***STATE SIGNIFICANT DEVELOPMENT
ASSESSMENT REPORT:***

***Sydney International Convention, Exhibition
and Entertainment Precinct (SICEEP), The
Haymarket SW Plot, Darling Harbour Sydney
(SSD 6011)***

***Mixed Use Residential Development and
Associated Public Domain Works***

Secretary's Assessment
Report Section 89H of the
*Environmental Planning and Assessment Act
1979*

Figure 12: One bedroom apartment (highlighted in red) within the projecting bay on the western elevation of building SW1 (Source: applicant's RtS)

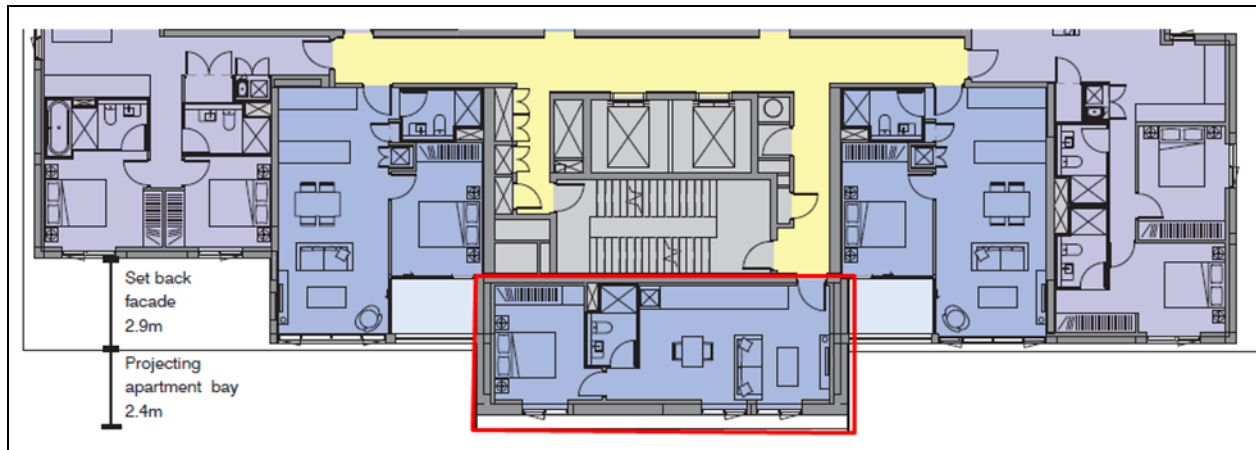
Council has raised concern about the projecting bay stating that it:

- is inconsistent with the Council's DCP, which allows a maximum 450mm overhang only in exceptional circumstances;
- is inconsistent with the building envelope of the Stage 1 Approval; and
- would add perceived scale/bulk to the building and would be overbearing on surrounding footpaths.

The department notes that the SW1 building was originally designed without a projecting bay and that the blank western elevation of the stair/lift core was visible for the entire height of the building above podium level. The department considers that the original design did not provide sufficient articulation and the blank expanse of the elevation failed to achieve an acceptable overall visual appearance. The department considers that the screening of the stair/lift core by the projecting bay significantly improves the overall appearance of the building and therefore is beneficial in urban design terms (refer to **Figure 13**).

The building envelope parameter plans for the Stage 1 Approval allows for the provision of a projecting bay measuring up to 12.5m wide and 2.5m deep (plus 500mm articulation zone). The proposed projecting bay (12.7 metres wide and 2.4 metres deep) and is therefore wholly within the building envelope provisions (including the articulation zone).

The department notes that the principal façade of the SW1 building is set back 12 metres from Darling Drive and the land within the setback would be used as a landscaped open space (including two rows of crowning trees) and pedestrian thoroughfare. The department considers, given the large setback and substantial planting that the proposed projecting bay would not be overbearing on the pedestrian environment.

Figure 15: Elements of the western elevation of tower SW1 (top) and southern elevation of tower SW3 (bottom) that are flush with and set back from the podium edge (Base source: applicant's RtS)

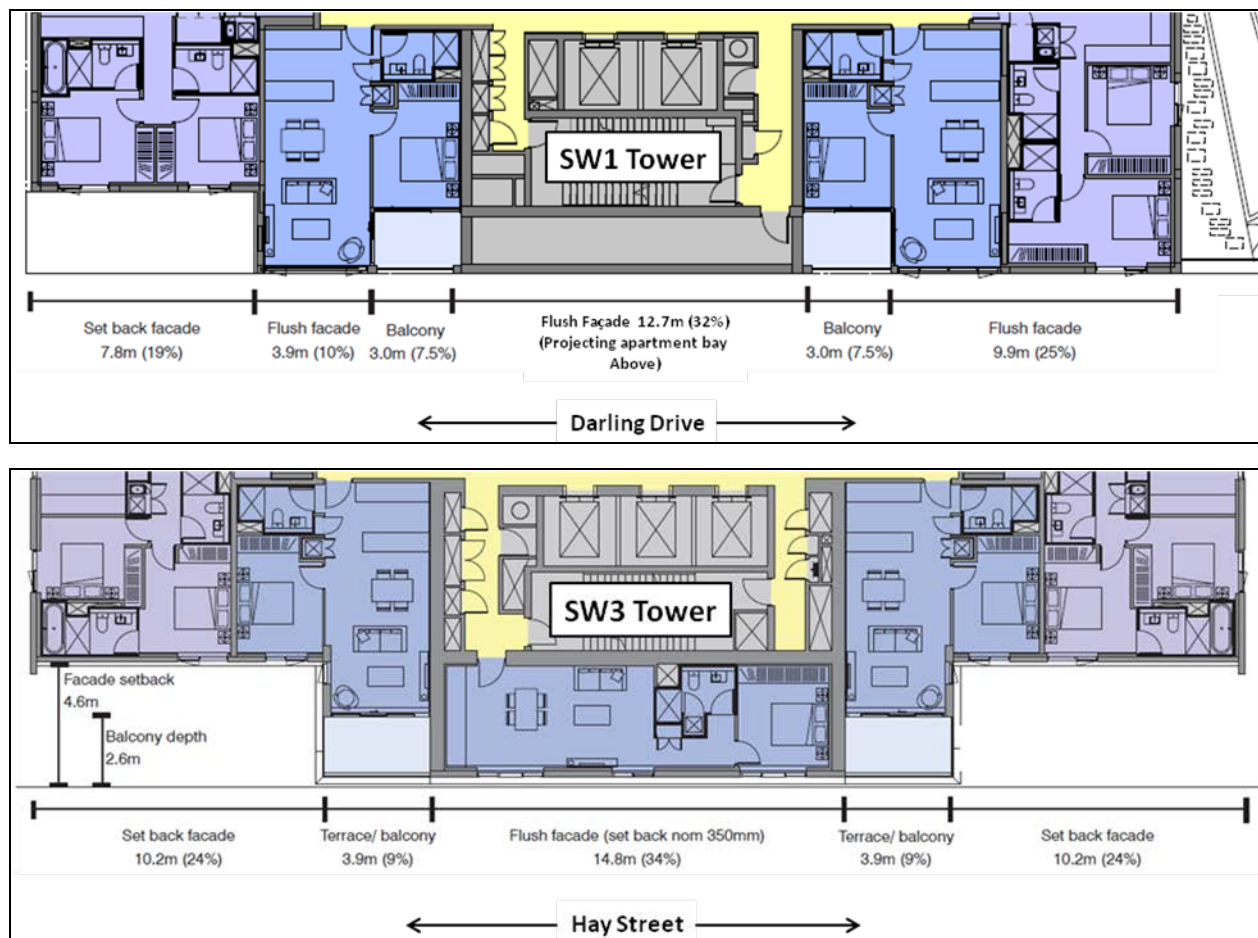
Council has reiterated its concern raised in its submission to the Stage 1 Approval that all towers should be set back at least 5 metres from the podium edge to provide an acceptable townscape response.

Both of the proposed towers include elements of built form flush with the podium edge as indicated below and shown in **Figure 15**:

- there is a change in materiality and architectural expression between the tower and podium which reinforces the difference between these forms;
- with regard to the SW1 tower, the projecting bay begins one storey above the podium roof level to reflect a notional re-entrant feature;
- with regard to the SW3 tower, the majority of the tower elevation is set back either 2.6 or 4.8 metres; and

- all 'flush' tower elements are set back 350mm from the podium face.

The department notes that the appropriateness of the tower and podium designs/setbacks were considered in detail during the assessment and determination of the Stage 1 Approval. The department considers, as noted in requirement B2, that an acceptable relationship between the towers and the podium can be achieved subject to architectural features being employed that appropriately separate the residential towers from the podium.

Figure 17: South West Plot vehicle entry point, pedestrian crossings and shared zone (Base source: applicant's RtS)

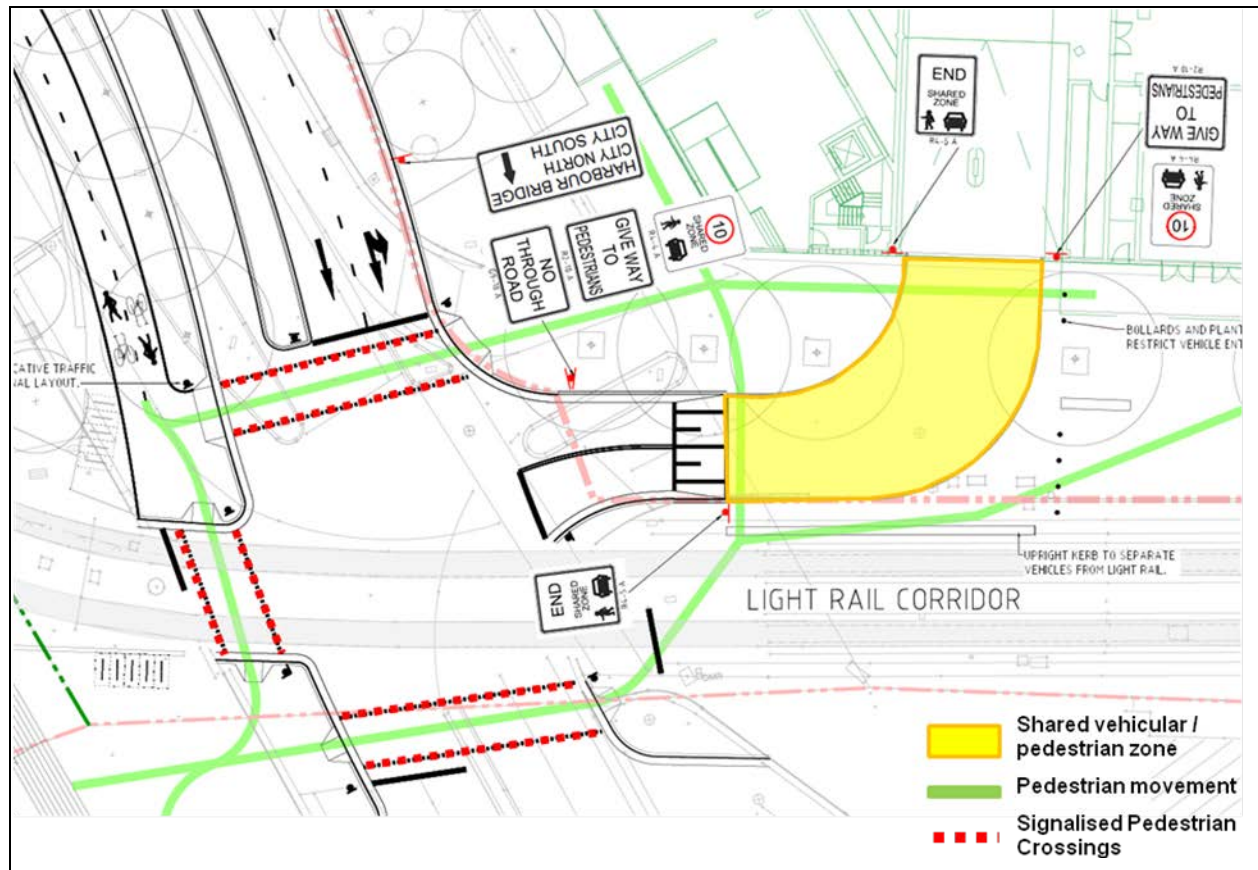
TfNSW raised the following concerns:

- the provision of one (rather than two) vehicular exit lane could cause delays to vehicles leaving the development and adversely impact on the operation of the Darling Drive/Hay Street intersection;
- the shared zone is not supported as it covers only some parts of the car park access and therefore could confuse pedestrians and motorists; and
- the speed hump / raised threshold is not supported as it could cause queuing out into the intersection and create an unsafe environment.

The applicant has confirmed that extensive traffic modelling was undertaken, in consultation with RMS, for the Stage 1 Approval and that the Darling Drive/Hay Street intersection would not be adversely impacted by the proposal. The applicant notes that the proposed shared vehicular/pedestrian zone will be clearly sign posted and designed to ensure that it will not cause confusion to vehicles or pedestrians. Further, sufficient space is allowed for within the design to ensure the speed bump would not cause unacceptable queuing.

Figure 18: Macarthur Street pedestrian connection interim solution, pedestrian route (top) and visualisation of lift/stairs (bottom) (Base source: applicant's RtS and SSD 5878)

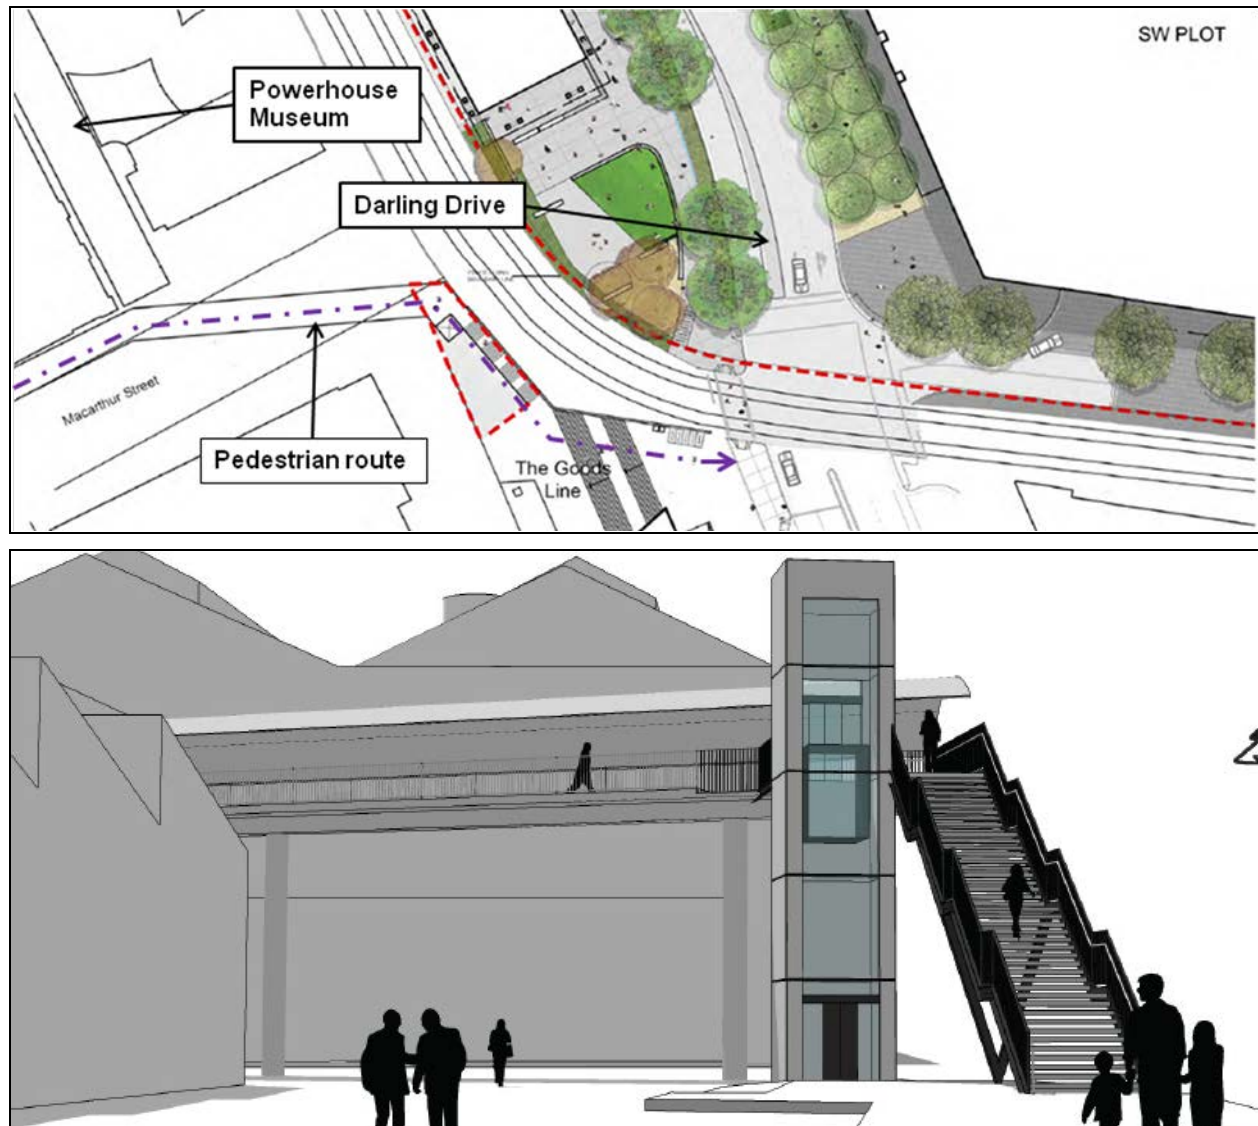
The proposal seeks to improve the existing east/west pedestrian connection between the site and Macarthur Street and in this regard proposes (refer to **Figure 18**):

- demolition of the eastern part of the elevated pedestrian footway located within the site boundary;
- erection of a lift and stairs connecting the retained portion of the elevated pedestrian walkway with the Goods Line; and
- creation of an at grade route from the lift/stair across the Goods Line and new pedestrian crossings at Darling Drive to the site.

The department considers that the proposed interim design represents an improvement over the existing, entirely elevated, pedestrian footway. The proposal would provide a clearer and more logical pedestrian connection from Hay Street to Macarthur Street. Furthermore, the interim design would better integrate the south west corner of The Haymarket with the Goods Line and also remove the unsightly elevated walkway currently spanning Darling Drive. The department notes that the route would be fully accessible as it is provided with a lift.
